File 1978-0131  
Date 10/2/00

Project Name: The Falls -Preliminary

REVIEW SHEET SUMMARY

ITEM Preliminary PD-8 - THE FALLS

Preliminary Development Plan For:  
**THE FALLS PHASE I**

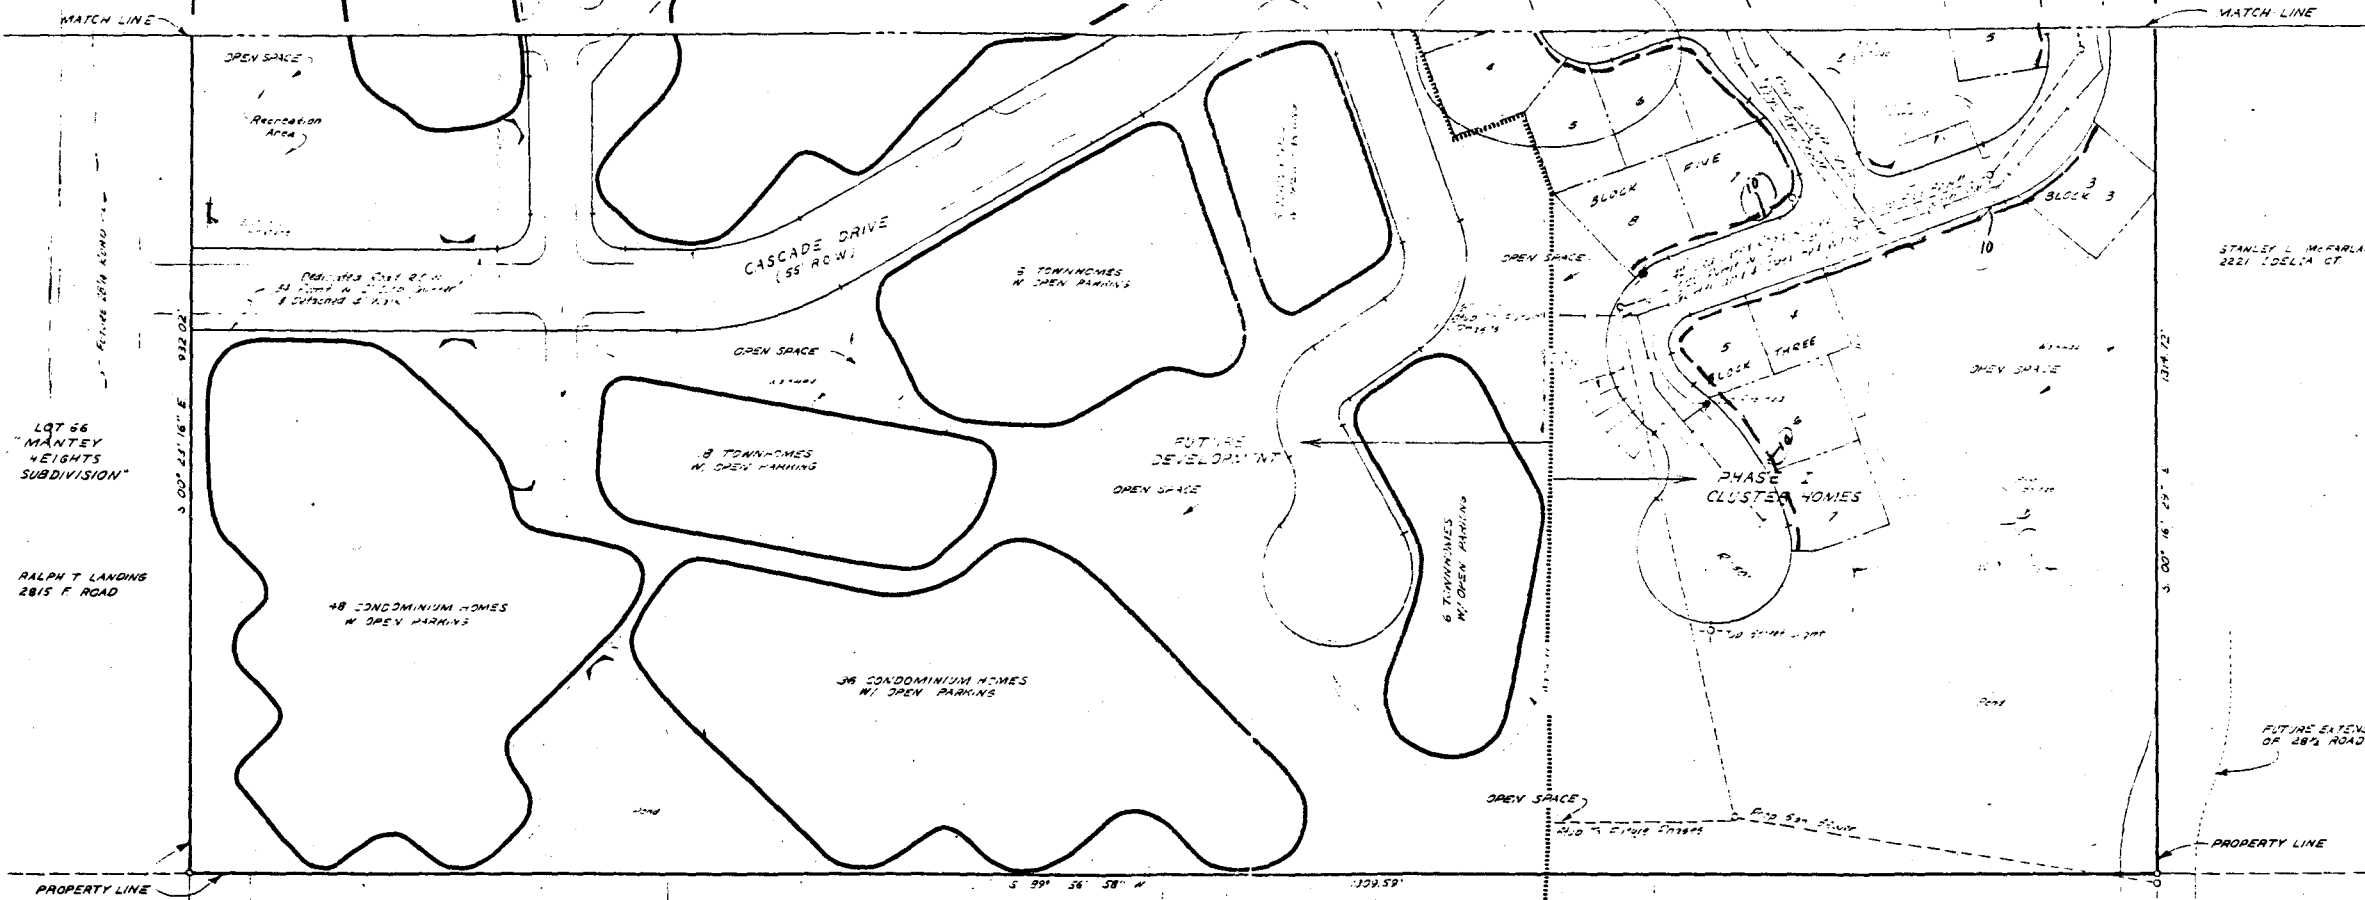
12-8-78	FIRE DEPT.	Since a cluster home is not typical single family dwelling and your future development is multi-family, the minimum line size needed is 8" loop with hydrants spaced at approximately 300 ft. apart. Besides the hydrants shown on plot plan, two more hydrants needed: West side lot 1, block 1, and N.W. corner lot 2, blk 3.
12-9-78	CITY UTILITIES	Must have a drain way maintained to drain Mantey Heights Water tank to the canal each fall and during other times when it may need draining. No water lines are shown into the Guest Parking areas off F Road?; However, a hydrant is shown. Should move hydrant to north end of Island for better placement. Prefer all container trash service in this development.
12-13-78	CITY ENG.-RISH	<p>(1) The proposed 42' ROW's should be 44' to fit new street stds. Since no on-street parking will be allowed on these, will adequate off-street spaces be available?</p> <p>(2) Council has budgeted for ROW acquisition and earthwork for 1979 for 28<math>\frac{1}{4}</math> Road from Orchard to Patterson. Because of topography, almost all of 28<math>\frac{1}{4}</math> will be off the Falls property but it will be immediately adjacent and is in my opinion a very significant access for The Falls. Will the developer assist us by obtaining 38.5' half ROW (east half) and granting power-of-attorney for full-street improvements on east-half?</p> <p>(3) Power of attorney should be granted for Patterson Road full street improvements. Other than accel-decel lanes, I recommend against any street construction on Patterson Road at this time.</p> <p>(4) Looks to me like some of the "on-street" sidewalks would be redundant with some paths. This should be studied and specific proposals made at final plat.</p> <p>(5) Looks like all streets planned conform to City Street stds (and they should) except for previously mentioned 44' ROW. If any sidewalks are deleted, ROW could be reduced by 4 ft.</p> <p>(6) Does not 2 on grading and Drainage plan mean the detention ponds will be overtopped and will flow across adjacent properties to the south to get to Grand Valley Canal? How often will this happen? (i.e. Est. storm frequency to cause overtopping and est. storm capacity of ponds?) Will any overtopping be controlled via providing overflow structures and positive improved outlet routes to the Canal? Will easements across properties to south be provided? Will Grand Valley Canal protest the flows being directed into their Canal? All these questions should be adequately addressed prior to final plat submittal since drainage outlet "system" may depend on the answers.</p>

12-13-78	CITY ENG-MCKEE	Street geometrics look okay. No parking on 22' wide mats. Street light needed on street at curve in block one at lot 5 or 6.

CITY COUNCIL - Approved subject to 55' st on "L" St. in upper left of development and adjust balance accordingly.
